AGENDA
PLANNING COMMISSION REGULAR MEETING
CITY OF FARMINGTON HILLS
MAY 21, 2026 at 7:30 P.M.
FARMINGTON HILLS CITY HALL – CITY COUNCIL CHAMBER
31555 W. ELEVEN MILE ROAD, FARMINGTON HILLS, MICHIGAN 48336
Cable TV: Spectrum – Channel 203; AT&T – Channel 99
YouTube Channel: <https://www.youtube.com/user/FHChannel8>
www.fhgov.com (248) 871-2540

A. [SITE PLAN APPROVAL 69-11-2025](#)

LOCATION:	35080 Grand River Avenue
PARCEL I.D.:	22-23-21-351-031
PROPOSAL:	Redevelop a 6.8 acre site to establish a “Customer Experience Center” for used vehicle sales and purchases within the B-3, General Business District.
ACTION REQUESTED:	Site Plan Approval
APPLICANT:	Carvana, LLC (Brendan Weak, Authorized Representative)
OWNER:	R S Grand River LLC

Site Plan Review for The City of Farmington Hills

SOUTH ELEVATION

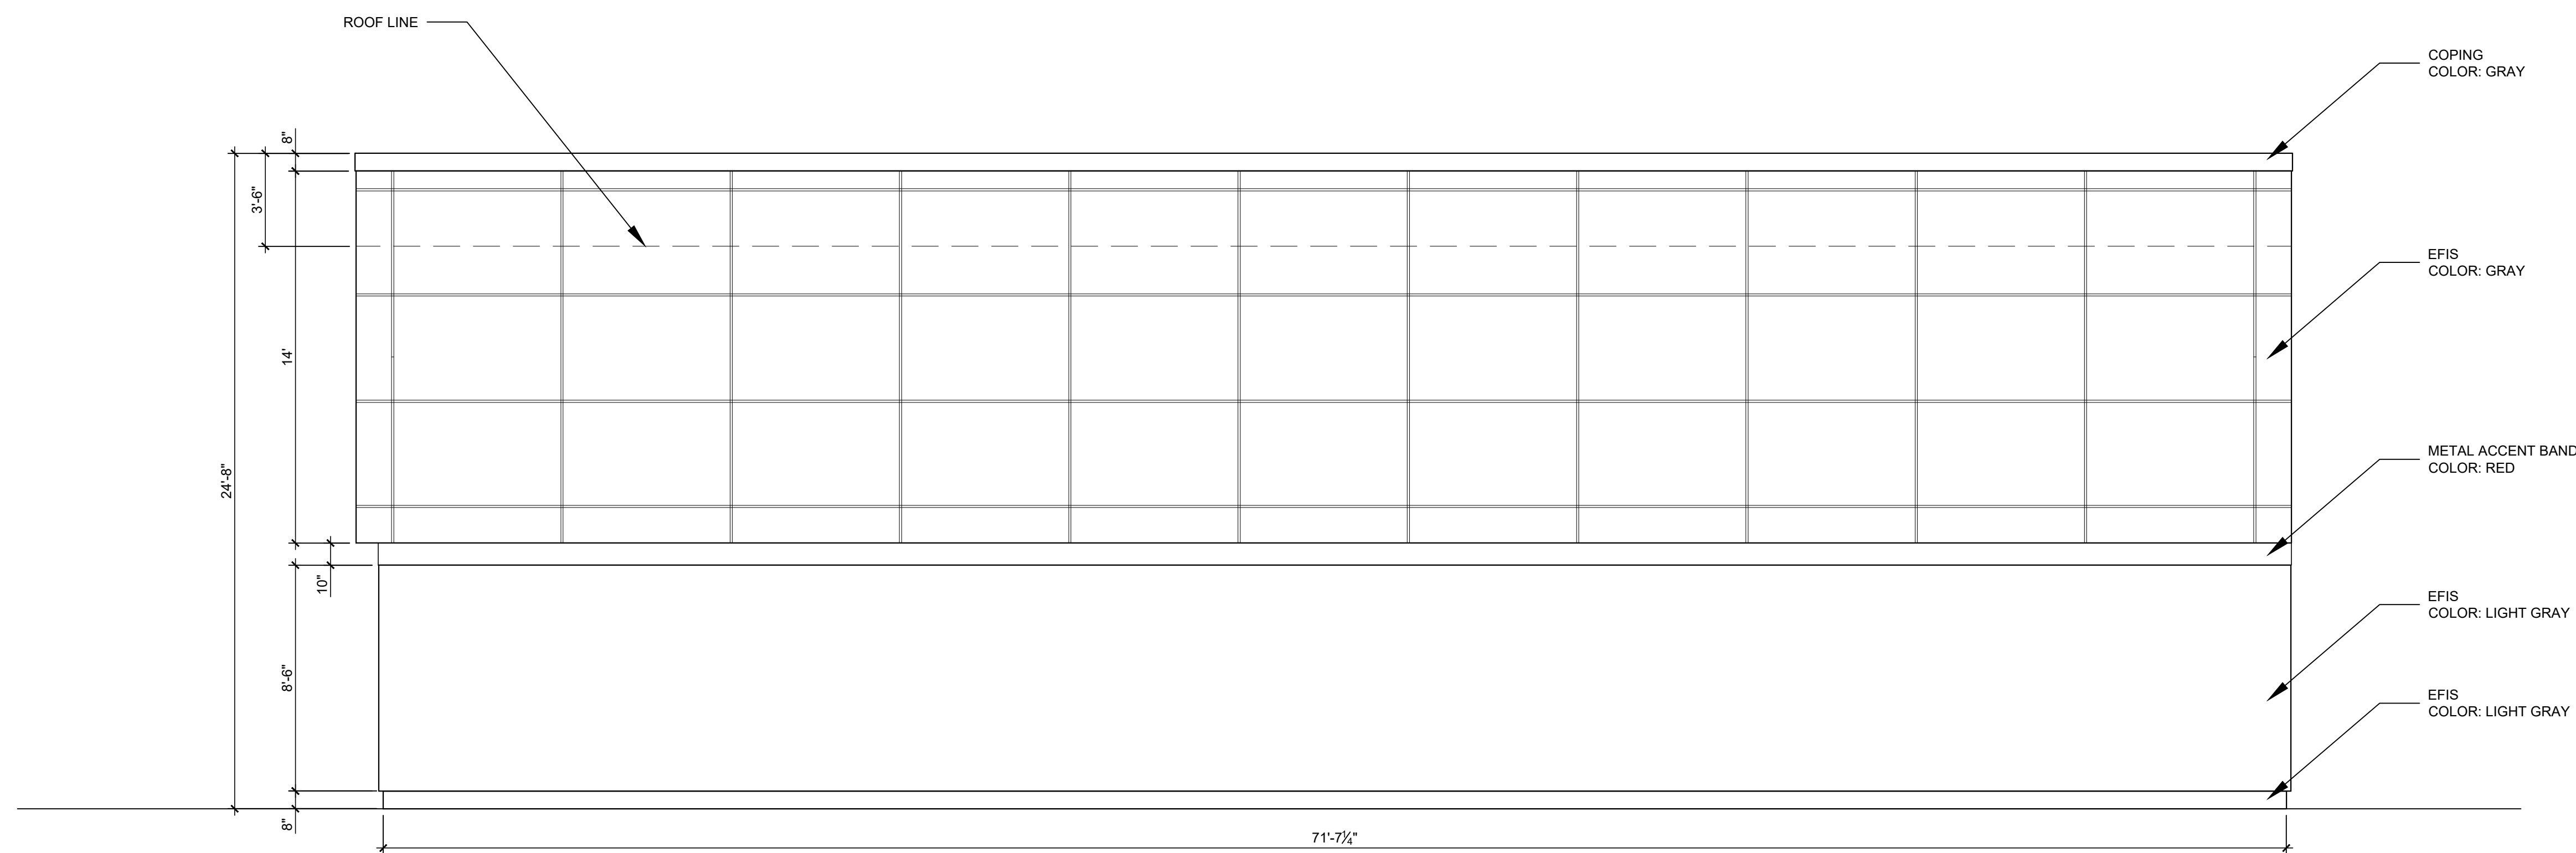
<p>Material Palette and Colors (34-5.20.4.C) All building materials and colors shall be clearly labeled on the proposed building elevation plans.</p>	<p>Pending. See comments above. Only front elevations were provided and colors were not provided.</p>

Design Standards	
Required	Provided
<p>Architectural Scaling (34-5.20.5) All façades oriented toward a public right-of-way must provide windows and architectural scaling elements (such as vertical pilasters, columns, or other architectural elements) to break up the scale of the building.</p> <p>Building façades shall include no less than two of the following elements:</p> <ol style="list-style-type: none"> i. Building color change. ii. Building material or texture change. iii. Projections or recesses extending along at least 20% of the façade. iv. Recessed entranceways or projecting vestibules. v. A horizontal expression line, such as a molding or reveal, shall define the transition between the ground floor and upper stories. If a one-story building is proposed, the horizontal expression line is not required. 	<p>Pending. See comments above. It is not clear from elevations submitted if the architectural scaling requirements have been met.</p>

Sheet Title:
ELECTRICAL PHOTOMETRIC SITE PLAN

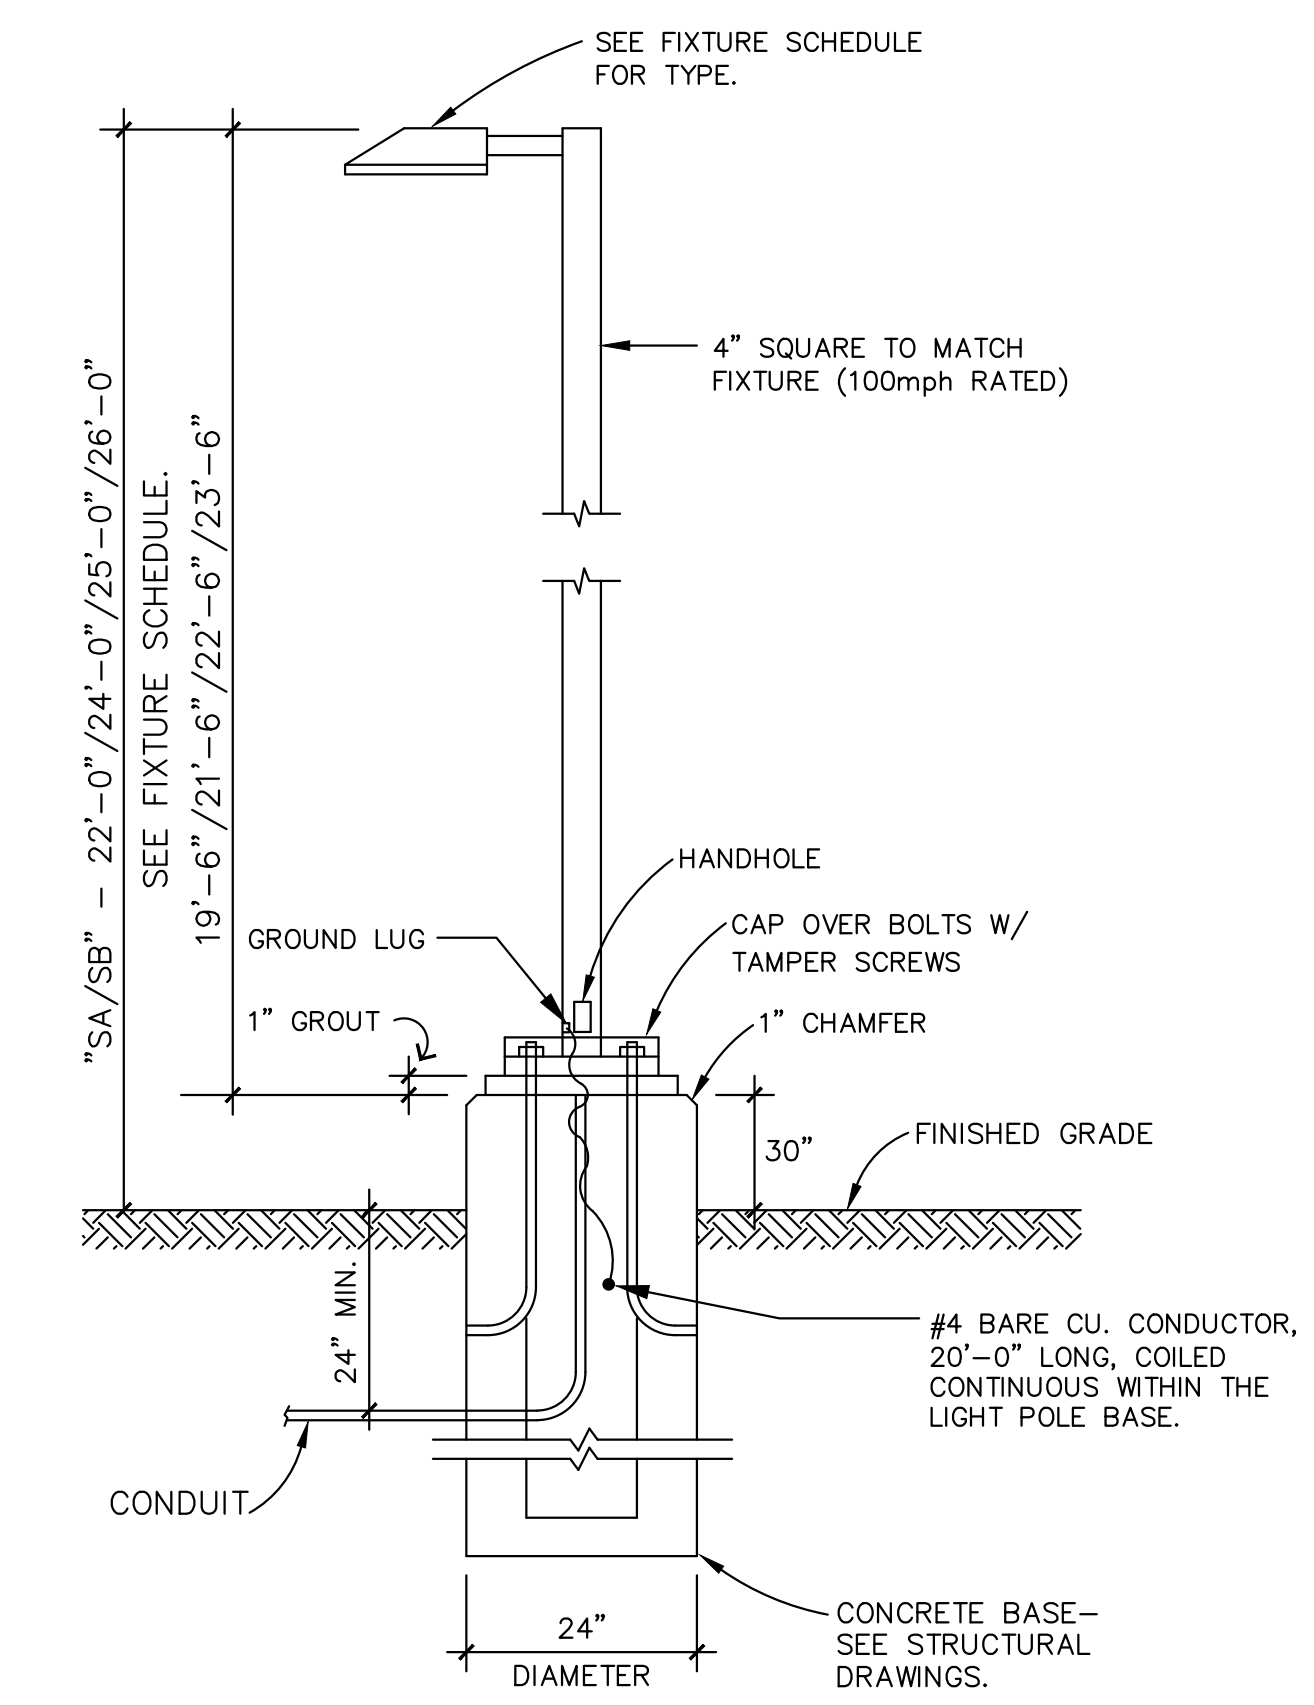
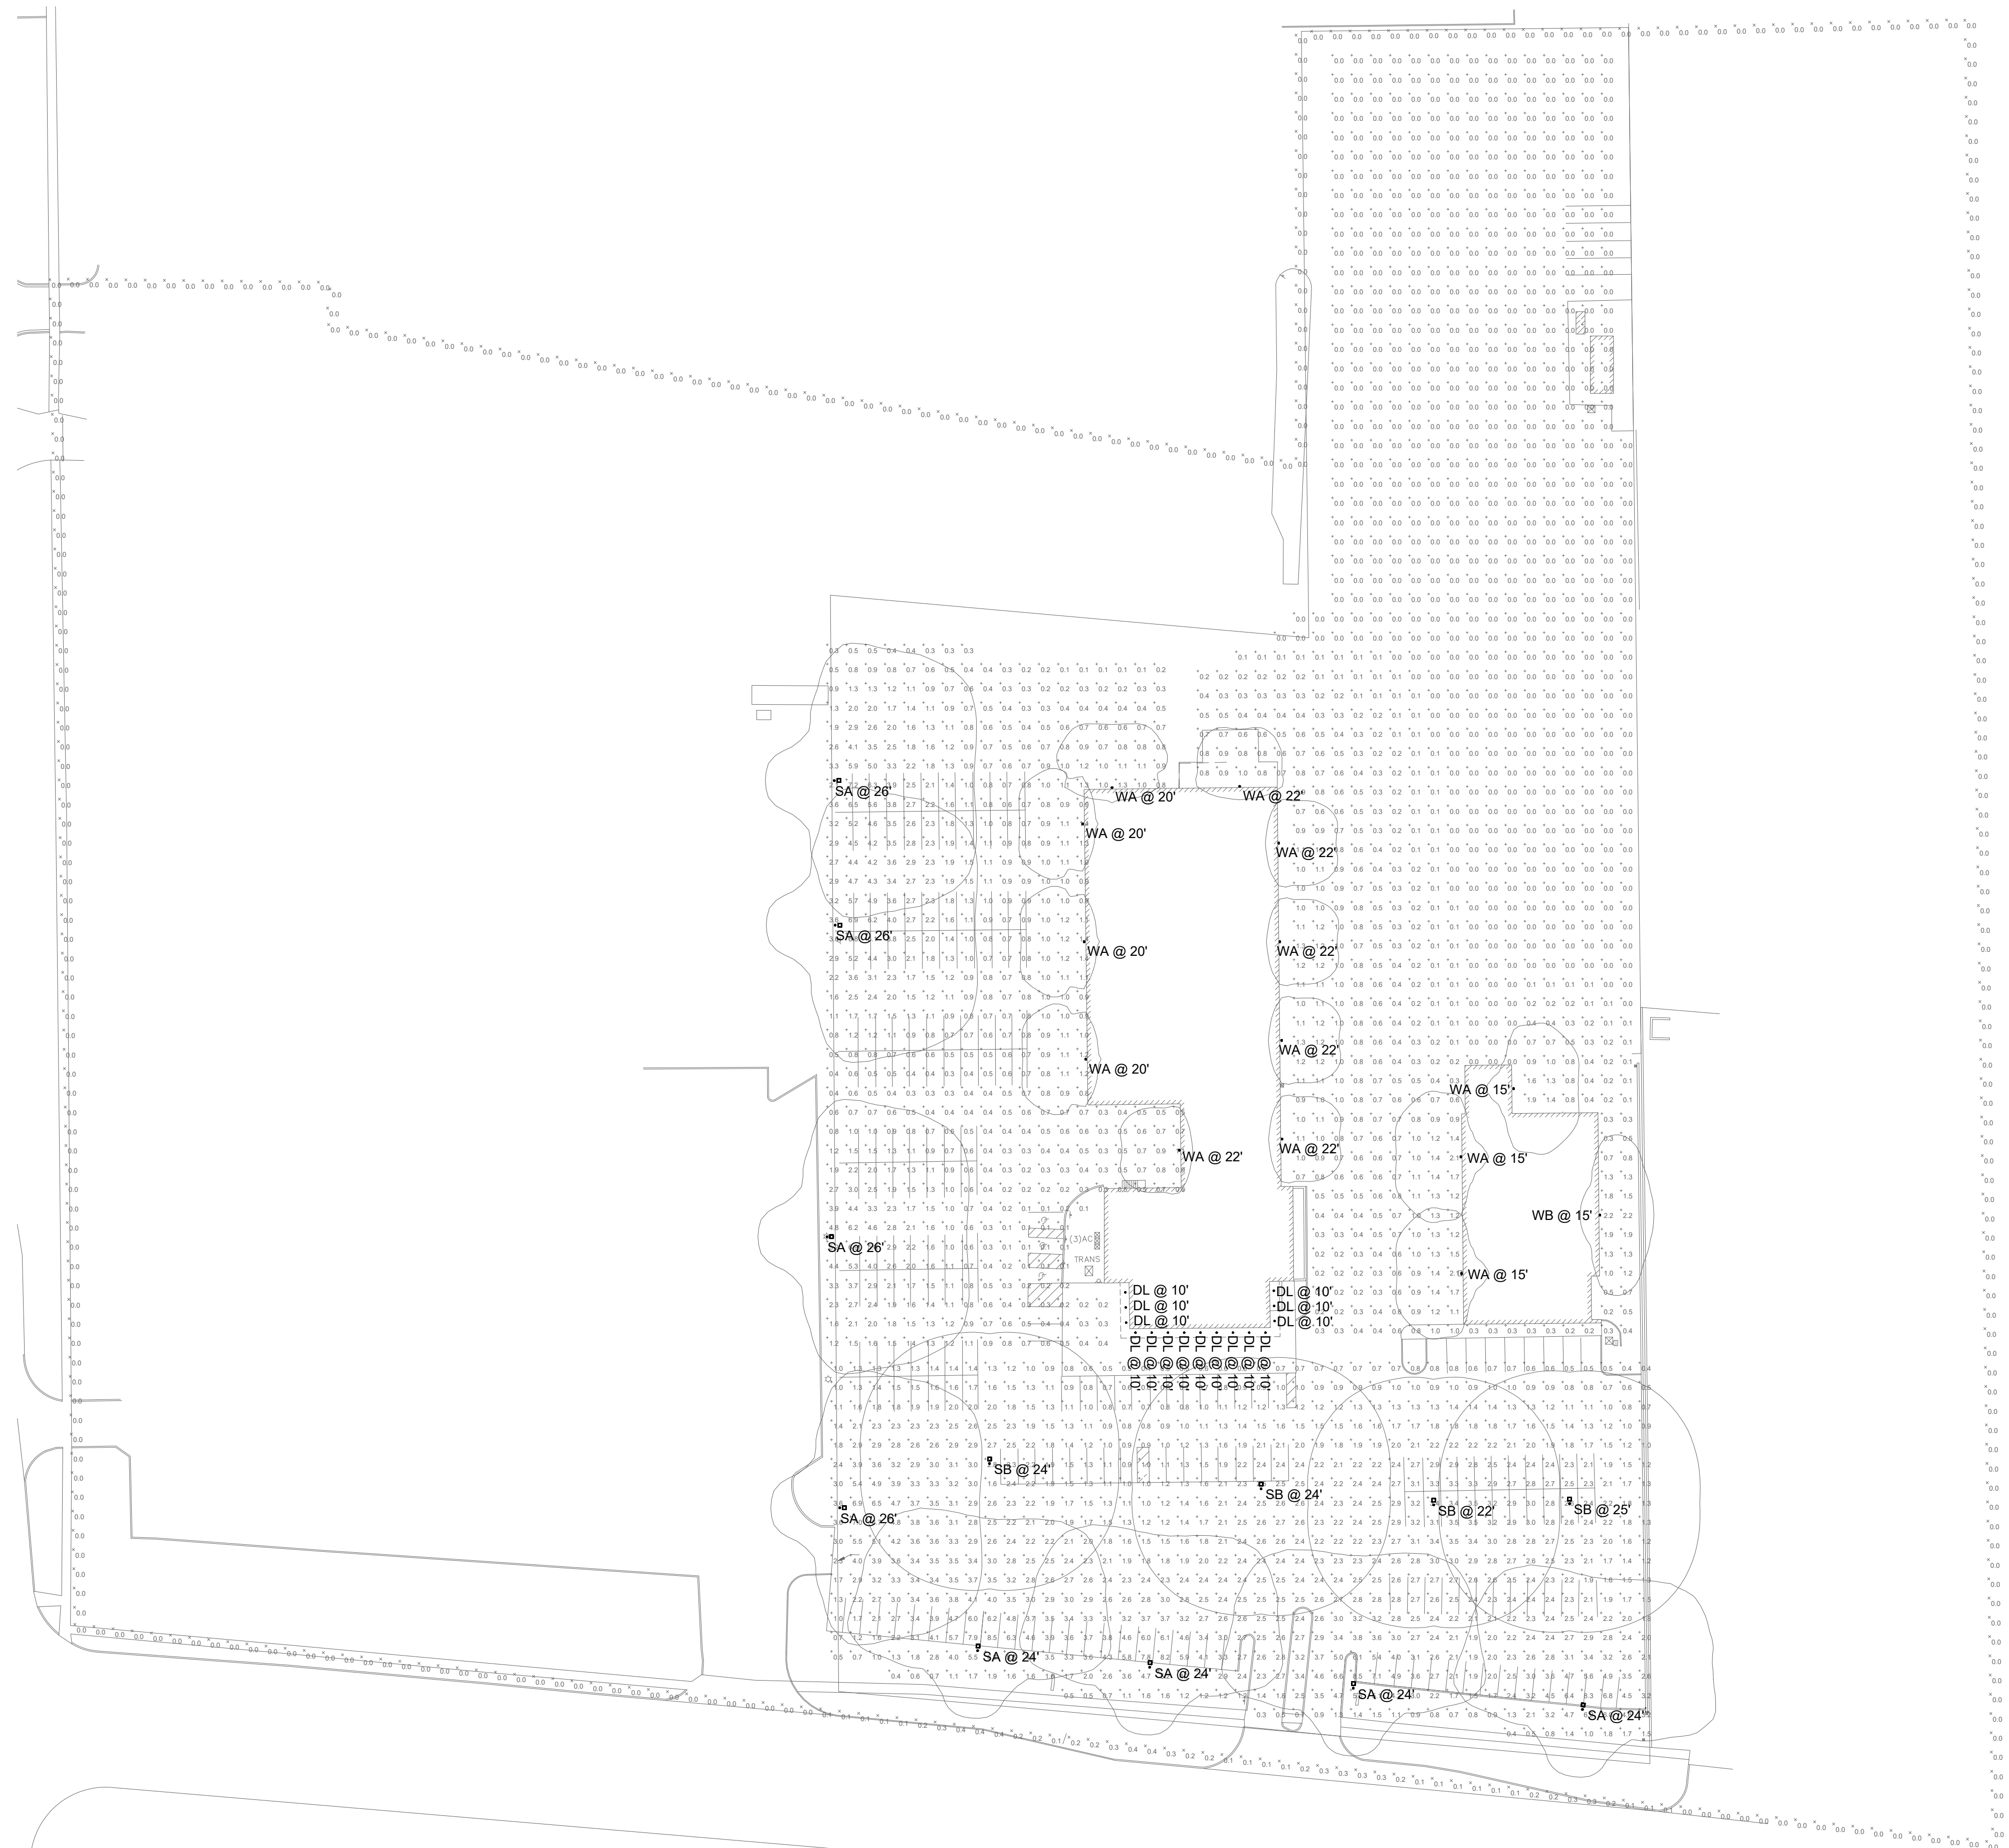
Compliant. The hours of operation noted on the site plan are from 7:00 am to 9:00 p.m. Monday-Saturday and the notes regarding exterior lighting are included on Sheet E0.1 (Photometrics) as required.

Average to minimum illumination ratio (34-5.16.3.C)	Lighting will be governed by the four to one (4:1) ratio of average to minimum illumination of the surface being lit.	Unknown. Applicant must provide the average to minimum illumination level for the overall the surface being lit.

Exterior Lighting		
Standard	Required/Allowed	Provided
Maximum illumination levels (34-5.16.3.C)	2.5 lumens per sq ft of hardscape area. 2,000 lumens per door. 160,465 x 2.5 = 401,162 lumens	Unknown. Applicant must provide the maximum lumens per sq ft of hardscape areas and per door.
Maximum illumination at the property line adjacent to non-residential (34-5.16.3.C)	(0.3) foot candles max.	Deficient. Maximum illumination levels (foot candles) exceeded in several locations along the property line including 4.8 on west, 1.8 on south, and 3.2 on east. The planning commission may modify these levels if such modifications are deemed necessary and appropriate to protect public safety.
Light source visibility adjacent to residential (34-5.16.3.B.iii.a)	No direct light source shall be visible at property line at ground level.	N/A
Maximum illumination at the property line adjacent to residential (34-5.16.3.B.iii.b)	(0.3) foot candles max.	N/A
